MANDATORY SERVICE BULLETIN

Service Bulletin No. 425C
(Supersedes Service Bulletin No. 425B)
Engineering Aspects are
FAA Approved

SUBJECT: Reprint of Teledyne Continental Ignition Systems Mandatory Service Bulletin No. MSB645

- SUBJECT:** INSPECTION OF RIVETED IMPULSE COUPLINGS AND STOP PINS
- REASON FOR BULLETIN:** To decrease operational wear rate of impulse coupling and to prevent engine stoppage.

FIGURE 6. SNAP-RING CAM ASSEMBLY IDENTIFICATION

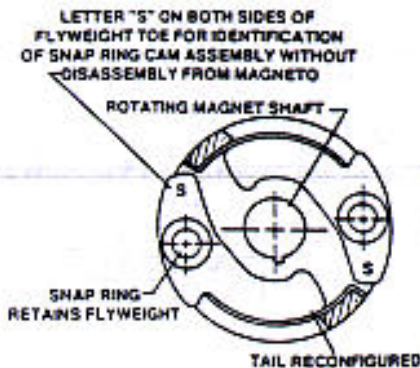
- B. Impulse coupling cam assemblies not meeting the criteria of this bulletin must be replaced with new snap ring cam assemblies.
 - C. As an alternative to recurring 100 hour inspections of RIVETED impulse couplings, operators may at any time either install improved snap-ring impulse coupling cam assemblies (see Detailed Instructions, Paragraph 2) or retrofit to Shower-of-Sparks Ignition where possible. Magnetos retrofitted with snap-ring impulse coupling cam assemblies may be identified as shown in Figure 6. Magnetos retrofitted to Shower-of-Sparks may be identified by part number.

- 2.4 Assemble impulse coupling and related drive parts onto magneto, following assembly instructions in the applicable magneto service manual.
- 2.5 Mark magneto data plate with letter "A" in lower right quarter to indicate snap ring cam assembly has been installed.
- 2.6 Install magneto onto engine and adjust timing as per engine manufacturer's latest published instructions.
- 2.7 Make an engine logbook entry indicating compliance with the replacement portion of this Service Bulletin. Include magneto part number and serial number in logbook entry.
